TOWN OF PARADISE VALLEY

Smoke Tree Resort

Major Special Use Permit Amendment

Town Council Work Study Session #1

HEIGHT

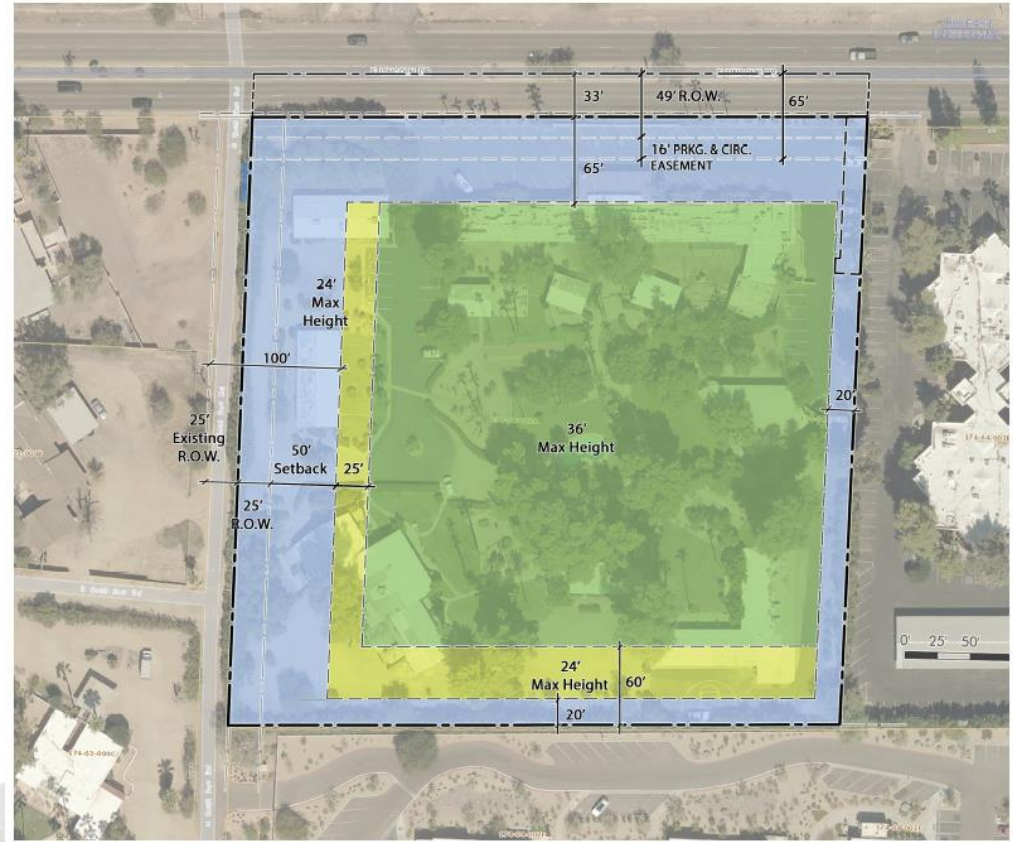
- **No major changes to the scope of the request although many documents have been updated to match the Planning Commissions discussion on certain items:**
 - **Height to top of mechanical screening lowered from 44' to 42'**
 - **Parts of the third story roof removed**
 - **Changes to signage plan, internal signs removed/resized**

PARKING

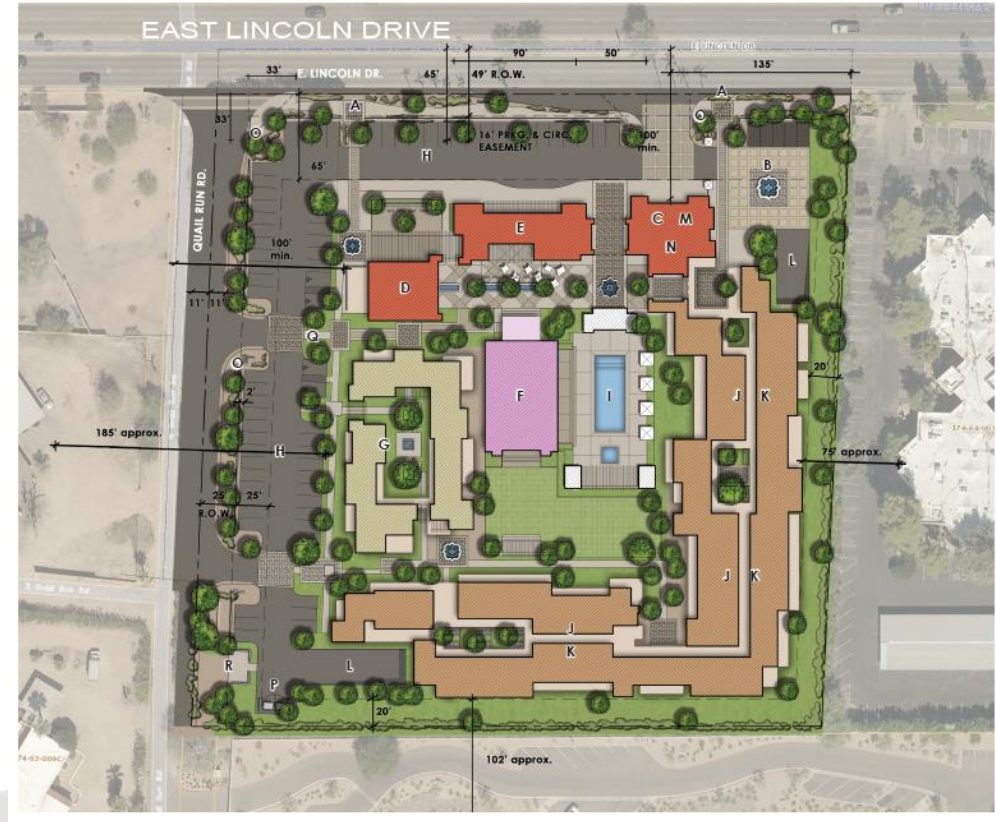
- 9x18 with 2' overhang on surface
- 1 space per 50 sq ft of meeting room
- 2 spaces per resort residential unit
- 1.05 spaces per hotel room proposed, not supported by third party analysis (1.2 per guideline)
- Internal capture rate for event lawn simultaneous use issue
- Engineering Dept with other internal capture assumptions

IMPACTS TO ADJACENT USES

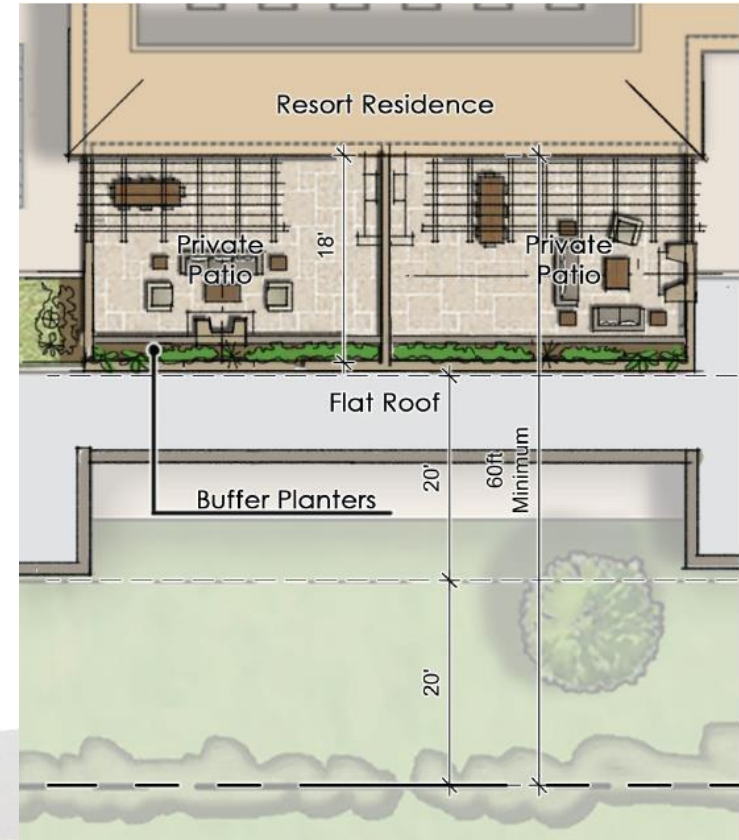
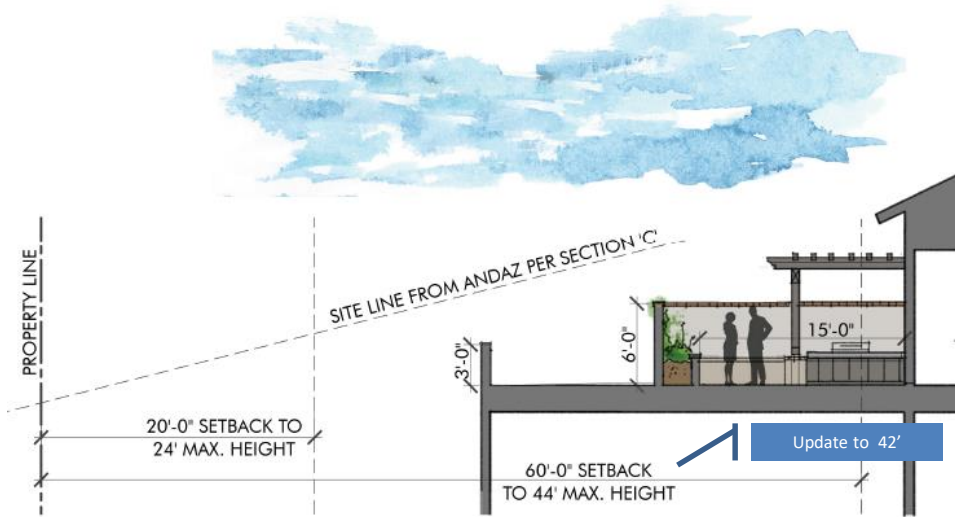
- Patios / Balconies removed from west property line
- South property line adjusted to not be seen from Andaz units

Lighting

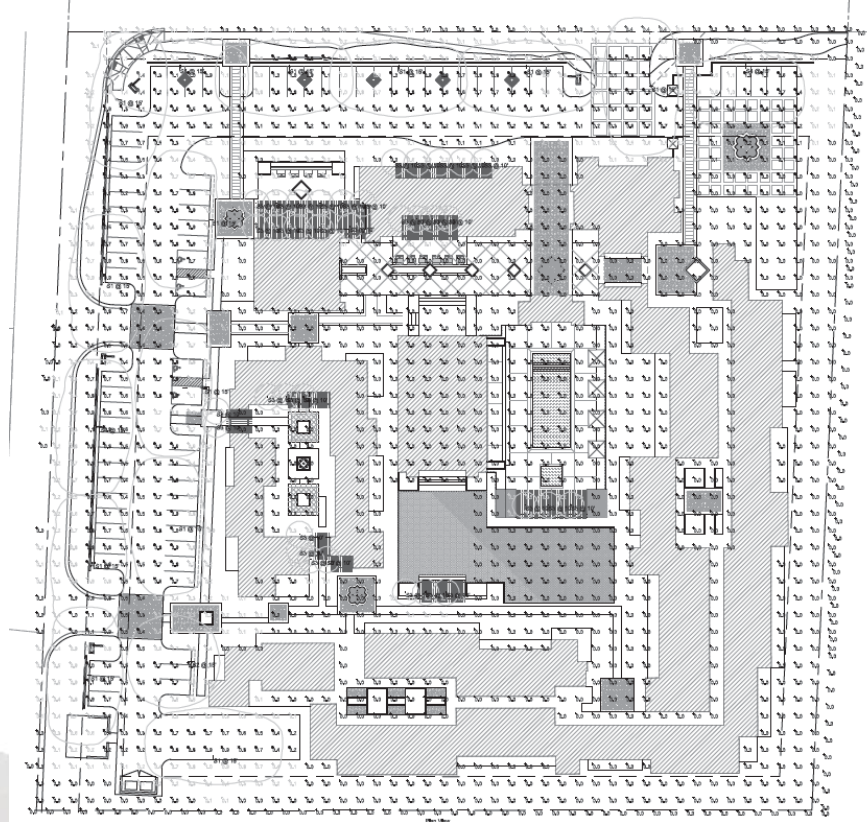
- To meet guidelines for Foot Candles and lumens
- Parking lot lights adjusted to be equidistant from property line as height of structure
- Light to be 3000K or less
